TECHNICAL BULLETIN Roofing Systems

Bulletin Number: T20-001 Date: January 13, 2020 Distribution: External

Johns Manville Peak Advantage® Guarantee – PVC 12' Mechanically Attached Approval

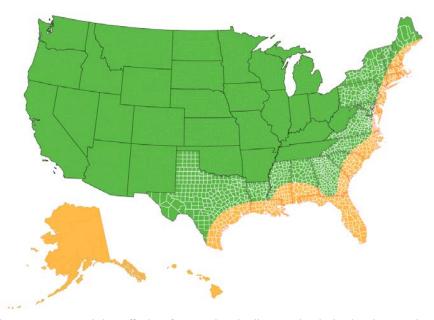
Johns Manville continues to expand the offering for mechanically attached single ply membranes eligible for NDL guarantees. The above map may be used as a guide to determine what areas of the United States qualify for standard JM Peak Advantage guarantee coverage (55mph maximum and 20-year NDL term) when installing mechanically attached 12' wide PVC assemblies.

- Buildings less than 60' in height located in the green region of the map need to meet the following requirements
 - o Steel deck minimum 33 KSI (22 gauge).

- Areas classified as special wind regions require review and approval by JM's Technical Specialist
 - o Field of roof installed with 12' wide sheets at 12" on center fastener spacing.

- Perimeter of roof installed with 6-foot-wide sheets with fasteners 12" on center fastener spacing.
 - Corners of the roof installed with 6' wide sheets with fasteners 12" on center fastener spacing and an additional row of fastening down the center of the sheet, stripped in.

- All perimeters must be calculated via FM's bulletin 1-29. Calculated partial perimeter areas will require the additional full sheet installation.
- All buildings located within the yellow region of the map require review by JM's Technical Specialist prior to any guarantee approval.
